2.0 SAFETY LIMITS AND LIMITING SAFETY SYSTEM SETTINGS

DAVIS-BESSE, UNIT 1

Amendment No. 17, 18, 22
8, 17, 80

Figure 3.1-3a Regulating Group Position Limits,
 0 to 325 ± 10 EFPD, Three RC Pumps --
 Davis-Besse 1, Cycle 6

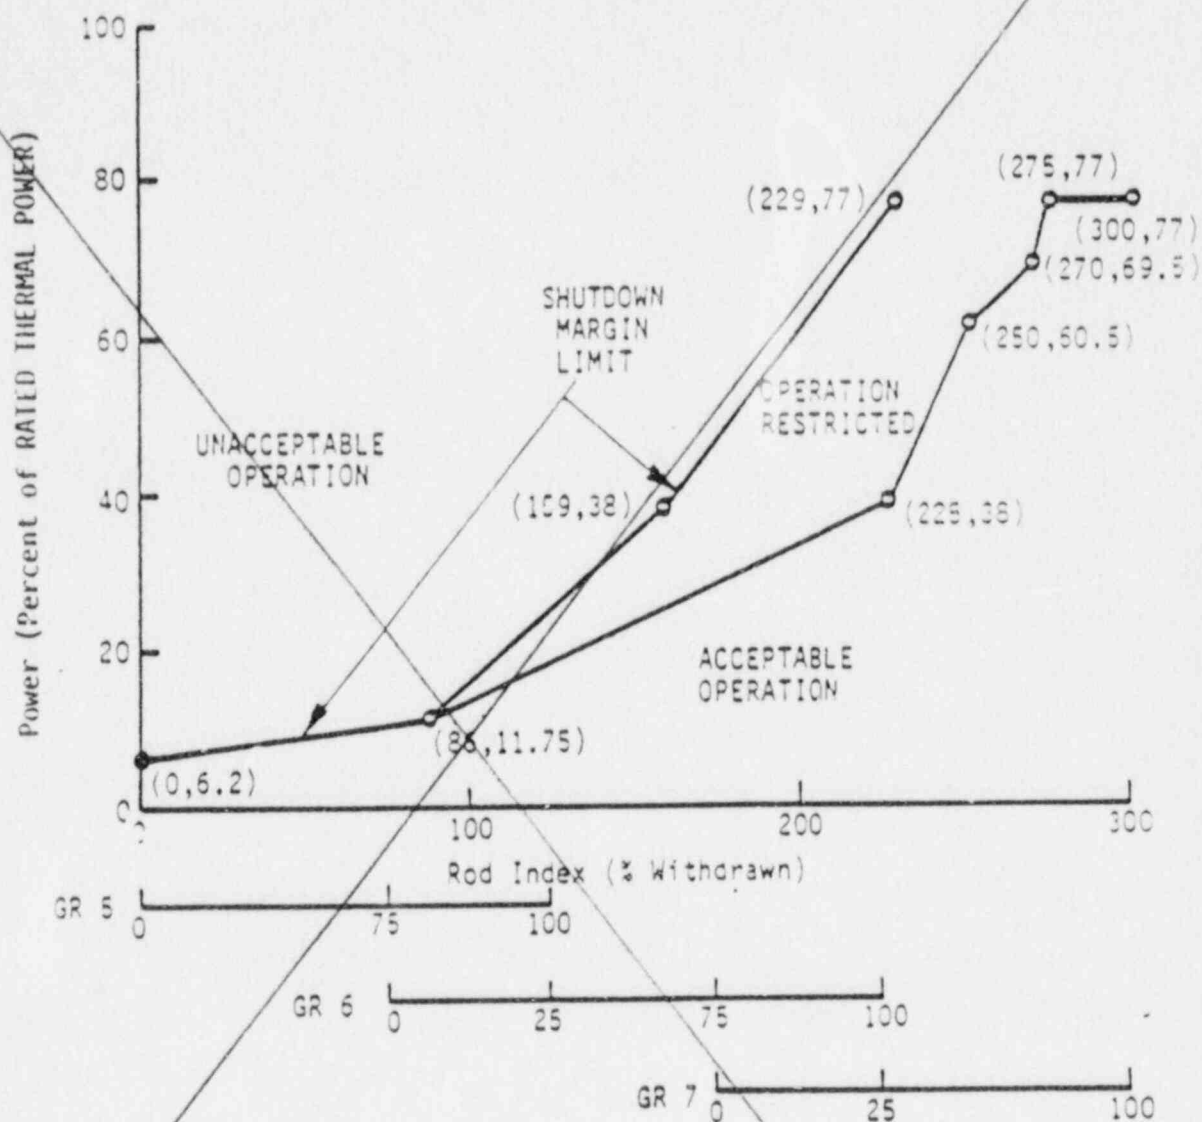
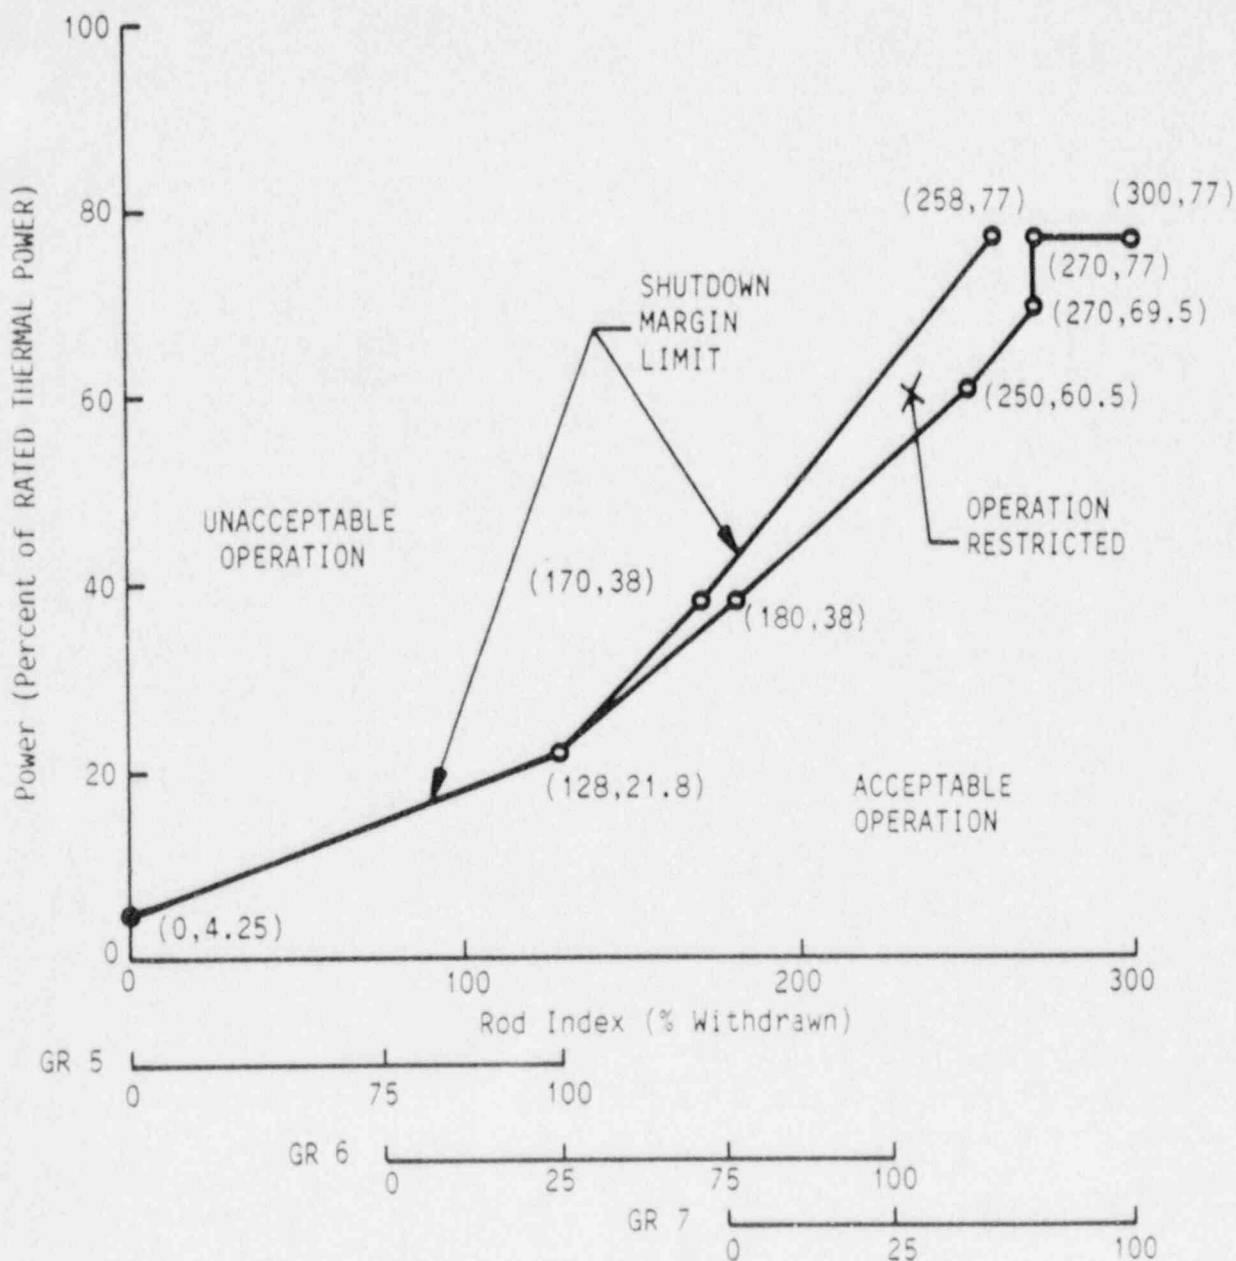
Superseded with new Figure 3.1-3a

Figure 3.1-3b Regulating Group Position Limits
 After 325 ± 10 EFPD, Three RC Pumps,
 APSRs Withdrawn -- Davis-Besse 1,
 Cycle 6

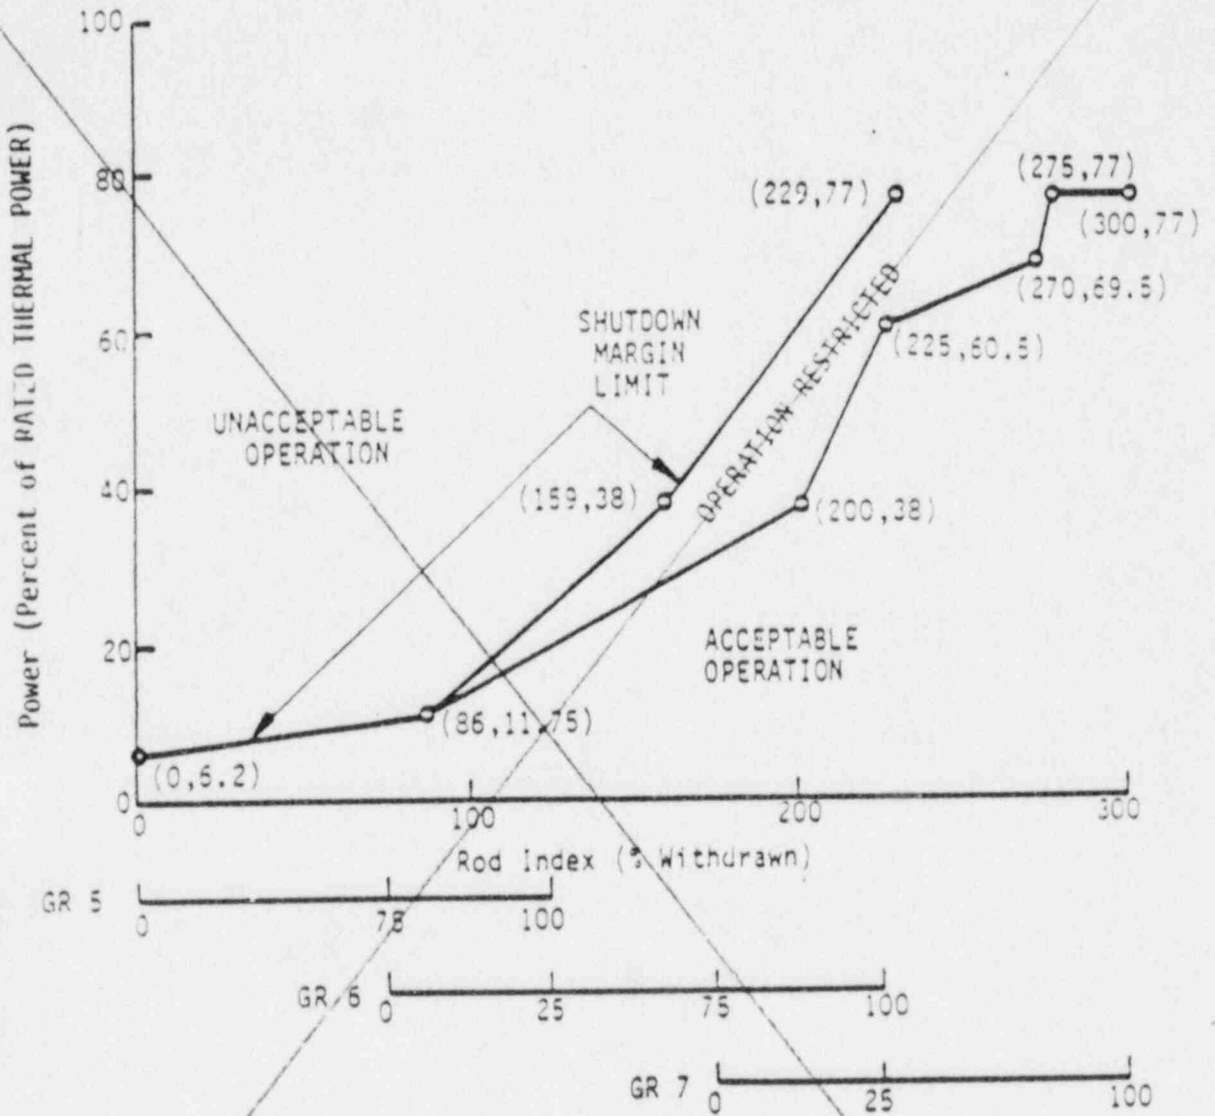
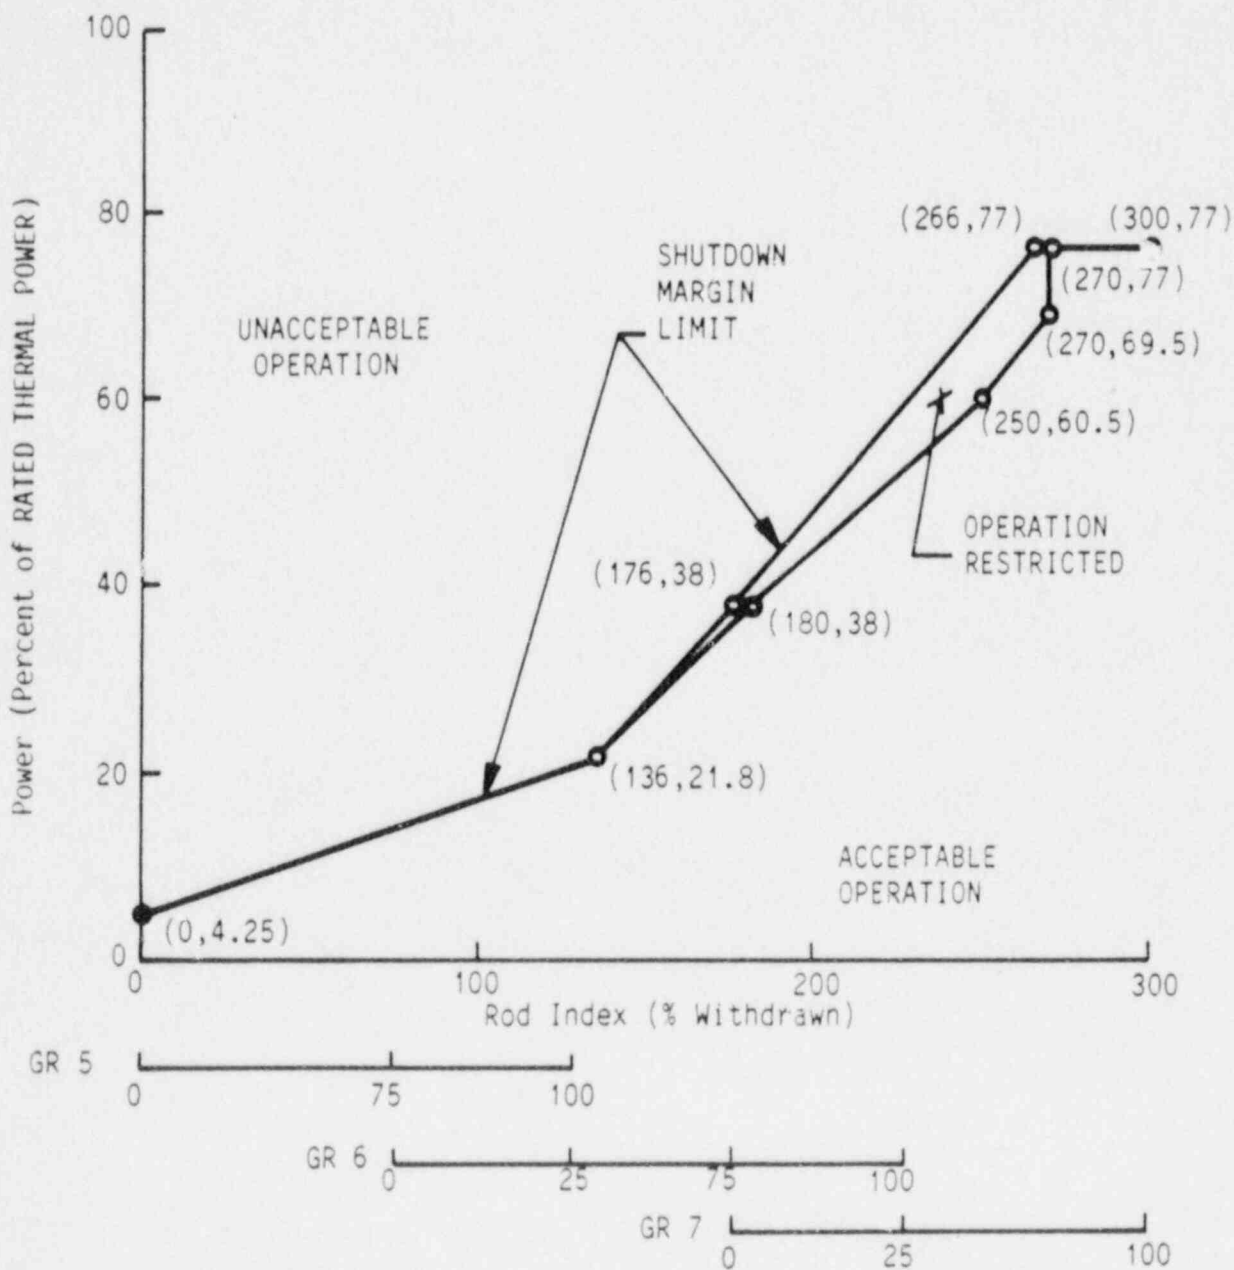
Superseded with new Figure 3.1-3b

Figure 3.1-4 Control Rod Core Locations and Group Assignments --
Davis-Besse 1, Cycle 6

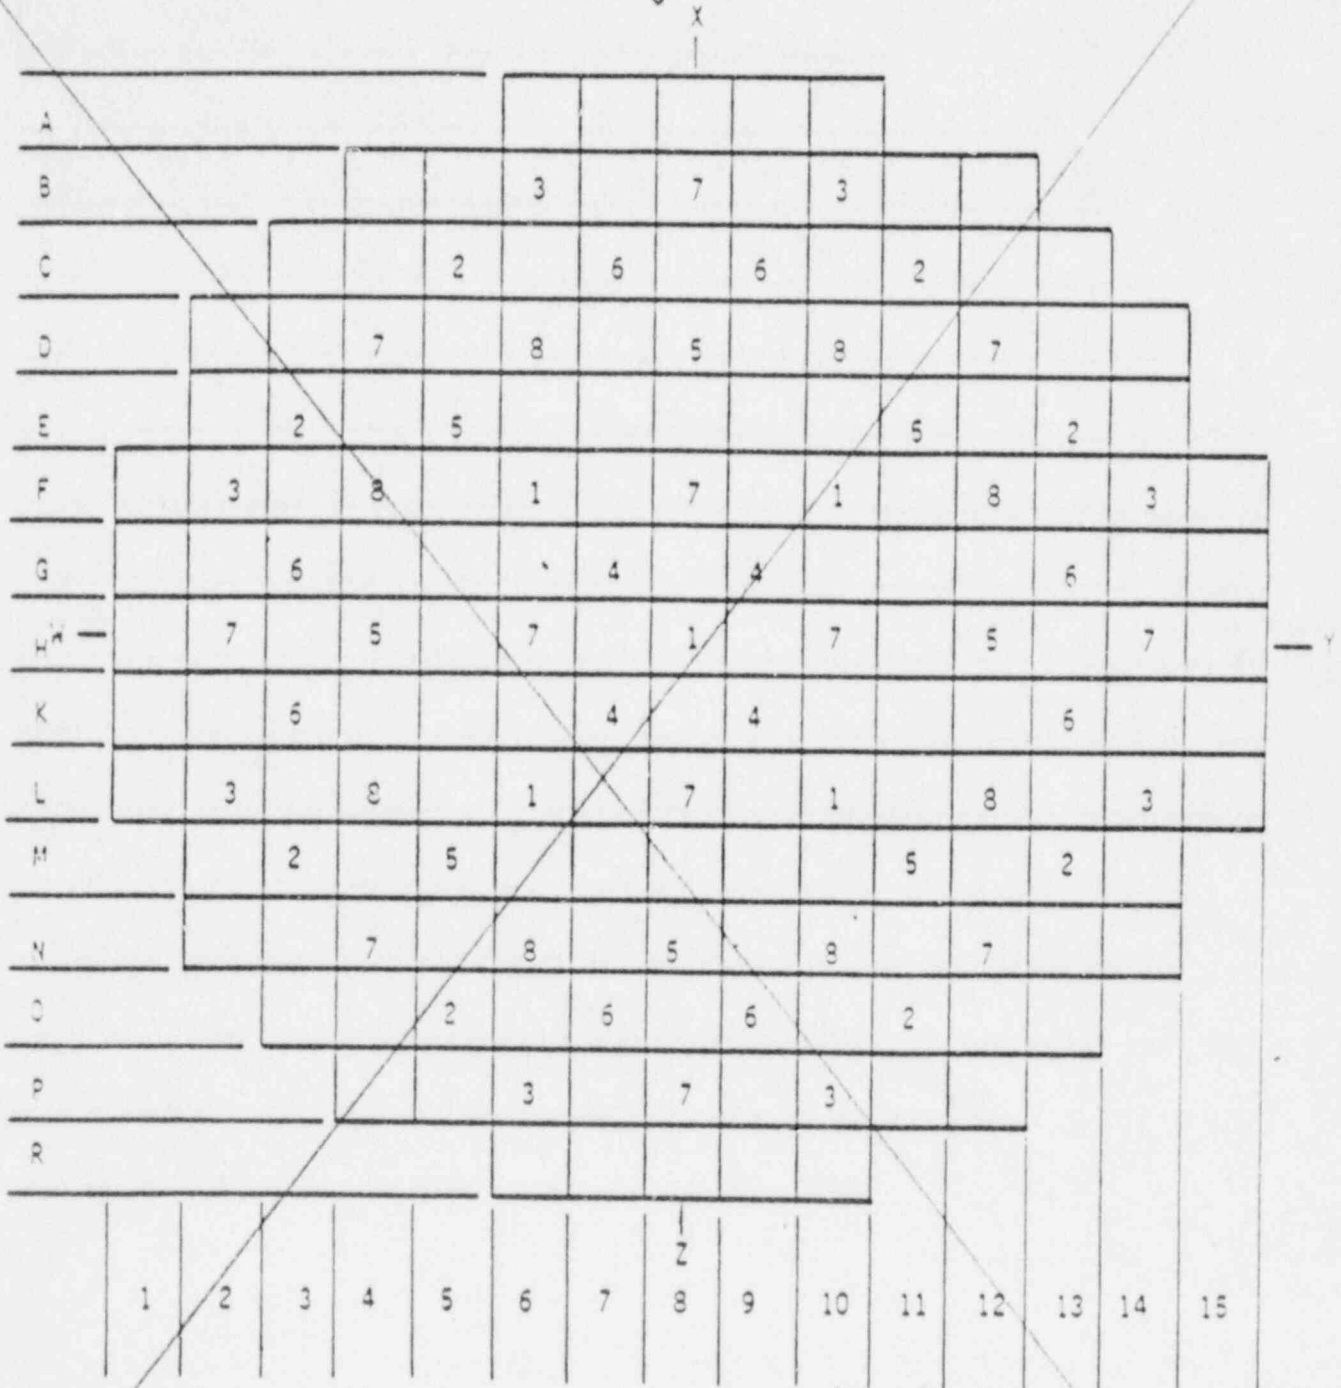
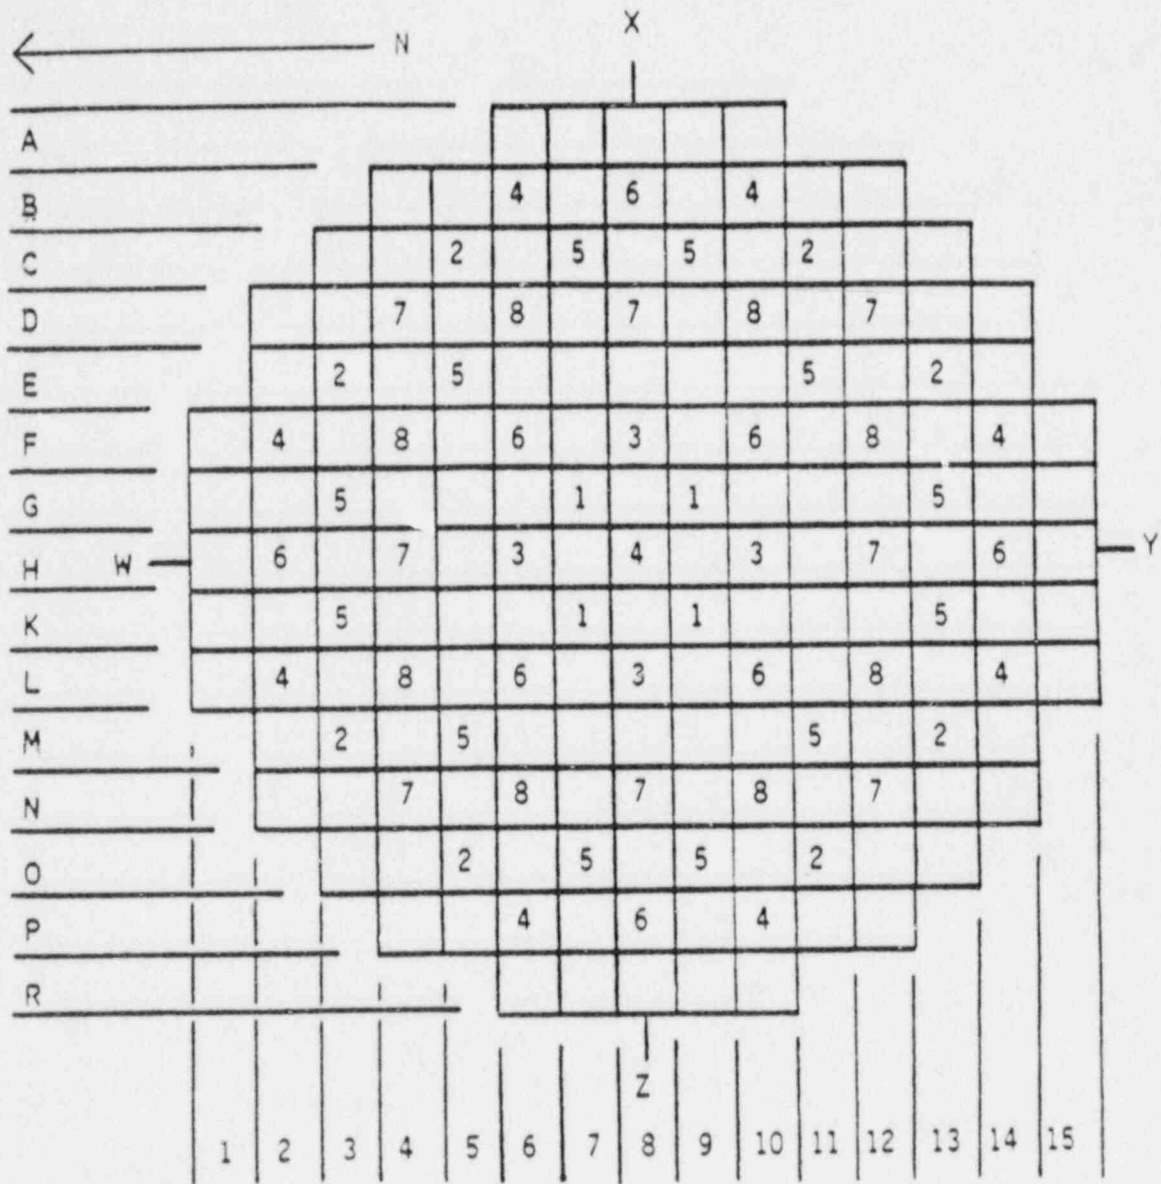
Superseded with new Figure 3.1-4

Group	No. of Rods	Function
1	4	Safety
2	8	Safety
3	4	Safety
4	9	Safety
5	12	Control
6	8	Control
7	8	Control
8	8	APSRs
Total	61

Figure 3.1-5a APSR Position Limits, 0 to 325 ± 10 EFPD,
Four RC Pumps -- Davis-Besse 1, Cycle 6

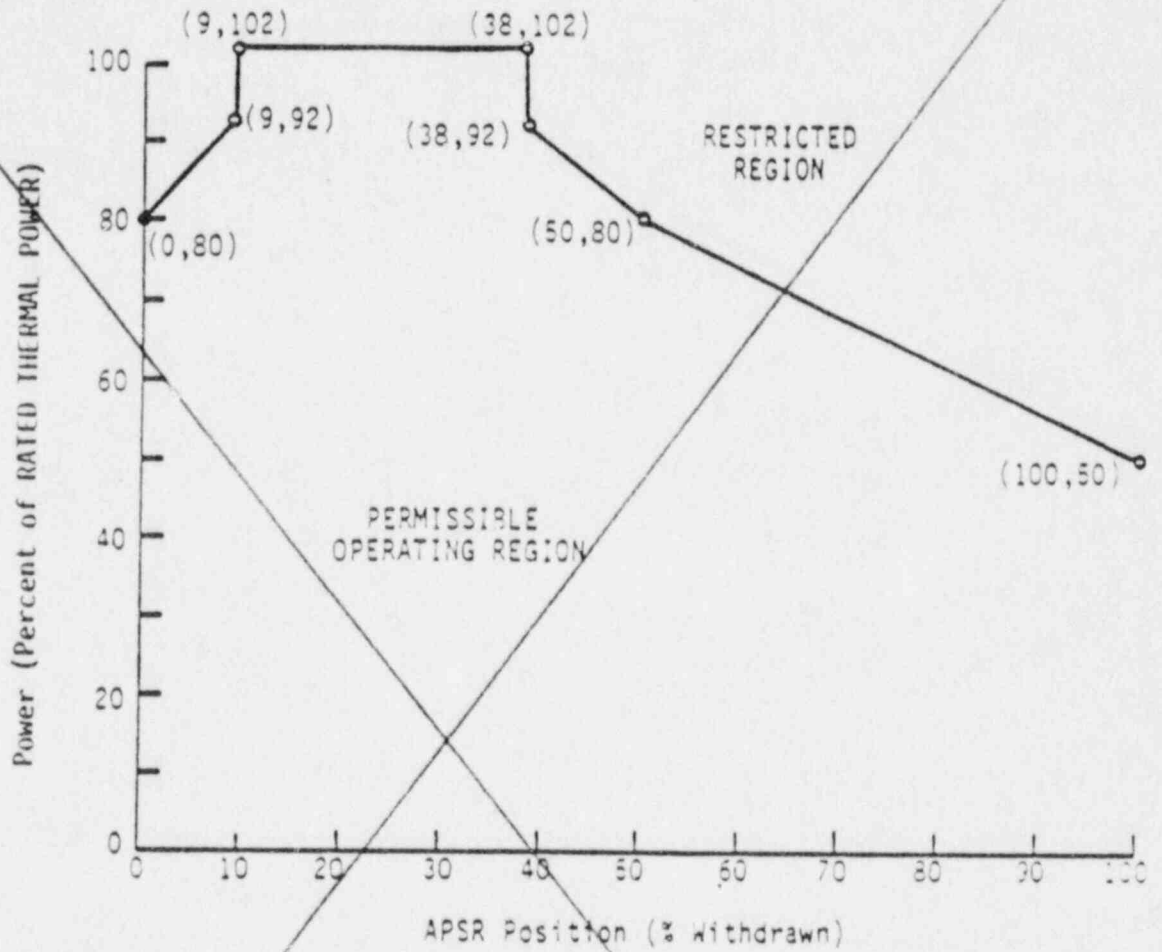
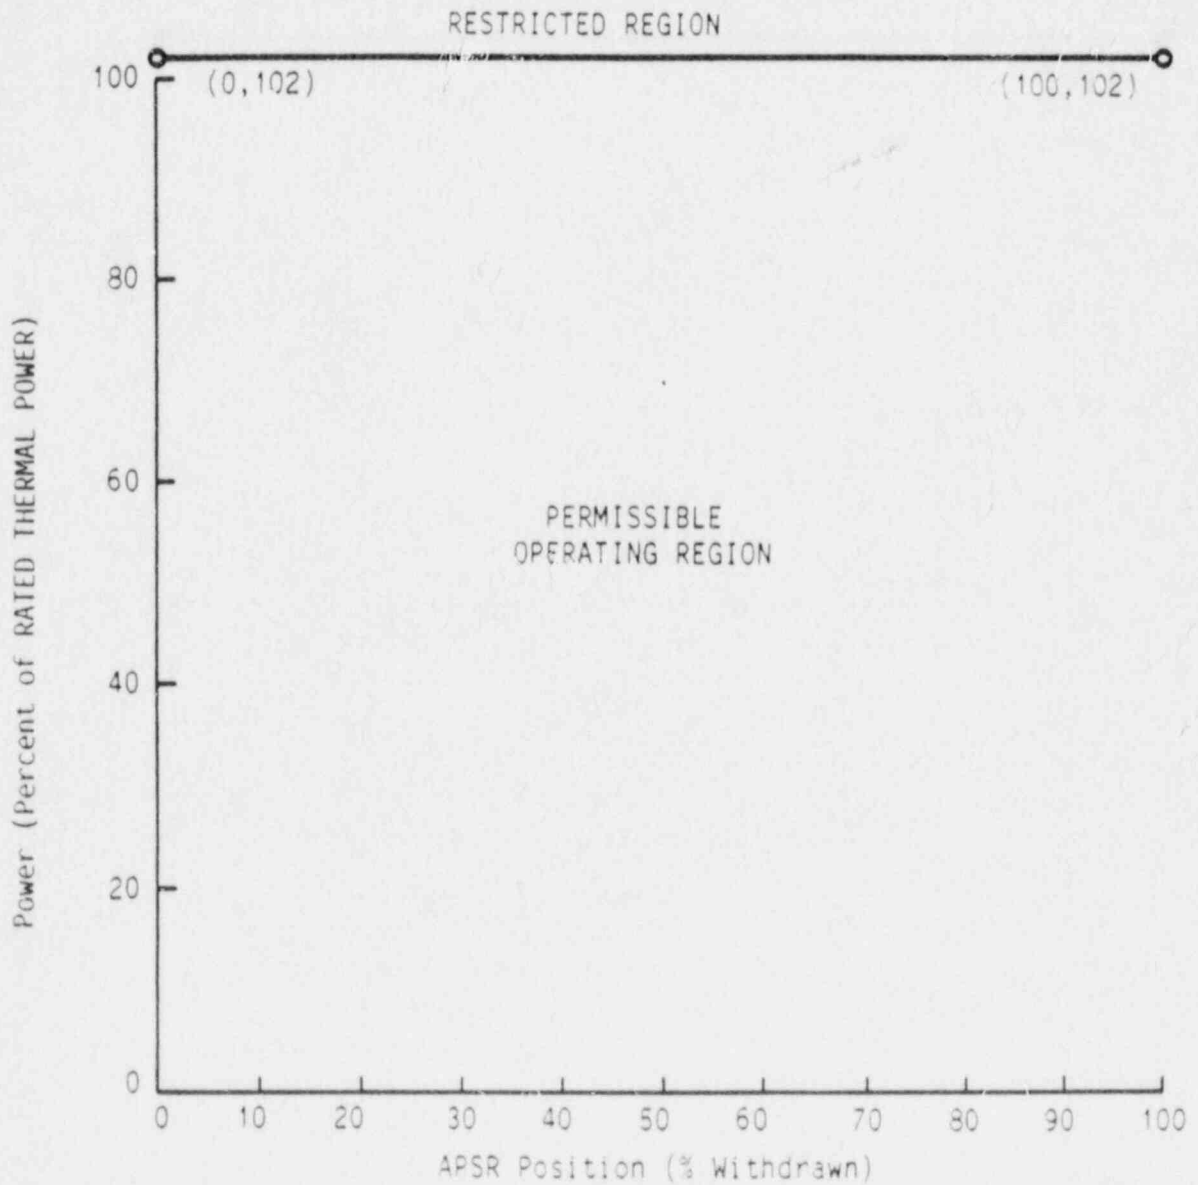
Superseded with new Figure 3.1-5a
